ADDENDUM TO CONTRACT DOCUMENTS

Project: DTCC Powerplant Education Facility – Sussex County Airport & Industrial Park – Georgetown, DE

Subject: **ADDENDUM NO. 4**

1
SKM-200-1
SCALE: 1/8" = 1'-0"

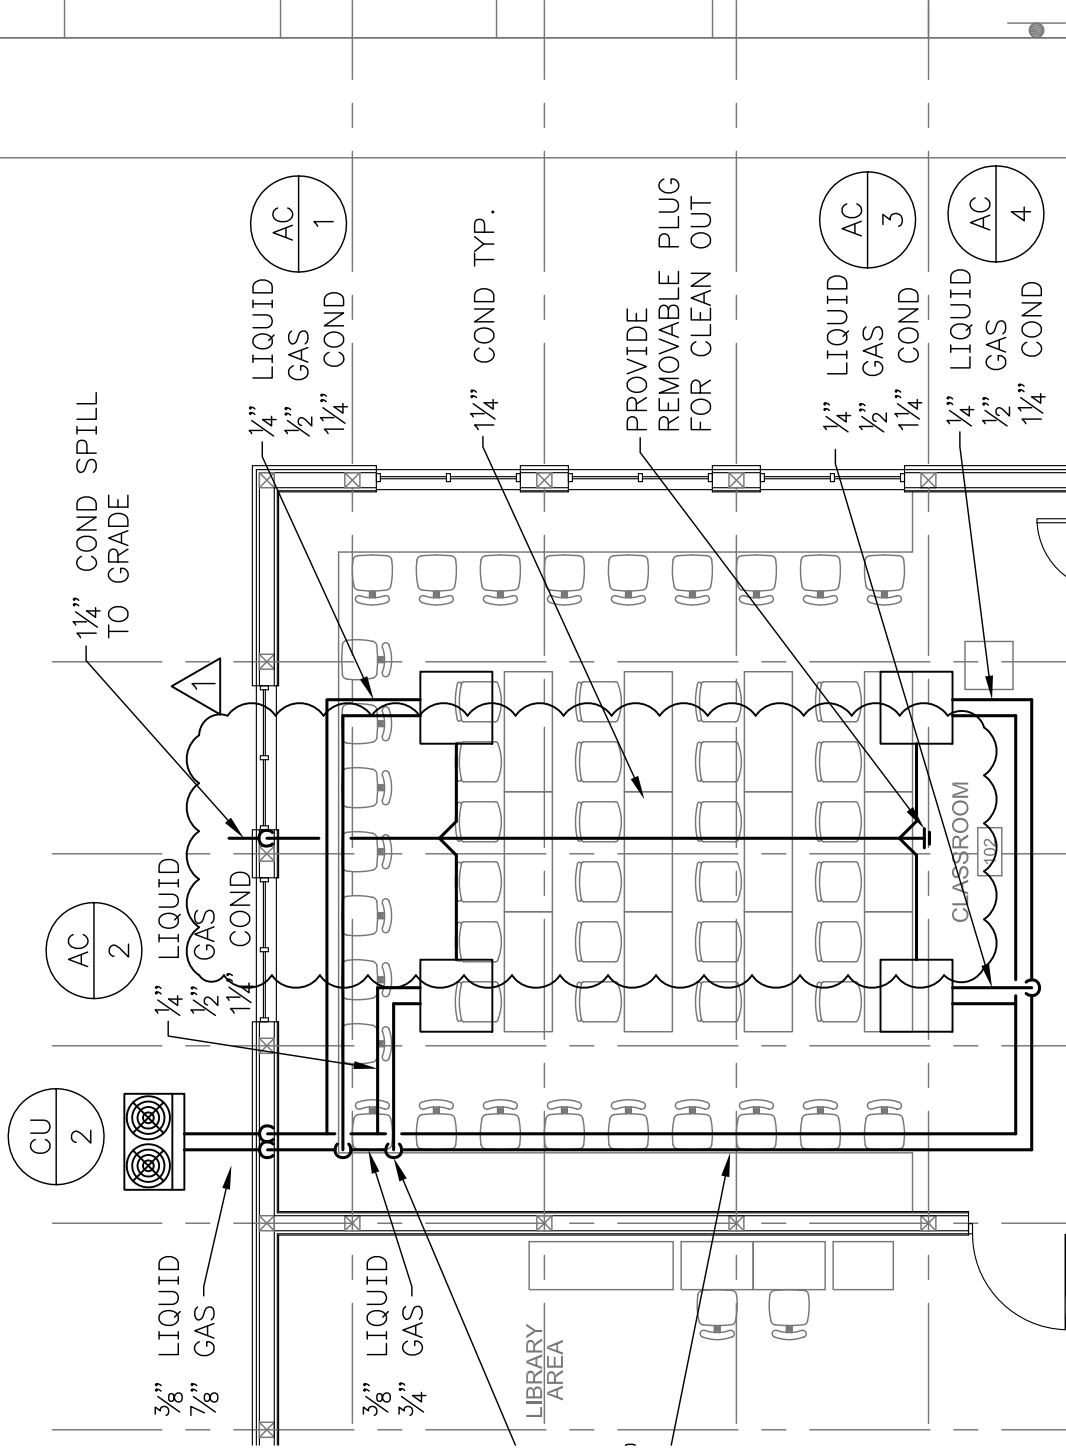
| 2 | M200; Mechanical Piping Plan: <ul style="list-style-type: none"> • Add enlarged Classroom Piping Plan 1 as shown on drawing SKM-200-1, dated 12/17/12. • Add enlarged Office Area Piping Plan 1 as shown on drawing SKM-200-2, dated 12/17/12. • Add Comment note No. 3 to AC-5 thru AC-8 and AC-10, in the Ductless Split Indoor Unit schedule, as indicated in drawing SKM-200-3, dated 12/17/12. • Add Comment note No. 4 to Comment noted for the Ductless Split Indoor Unit schedule, as indicated in drawing SKM-200-3, dated 12/17/12. • Add Comment note No. 4 to AC-9, in the Ductless Split Indoor Unit schedule, as indicated in drawing SKM-200-3, dated 12/17/12. |
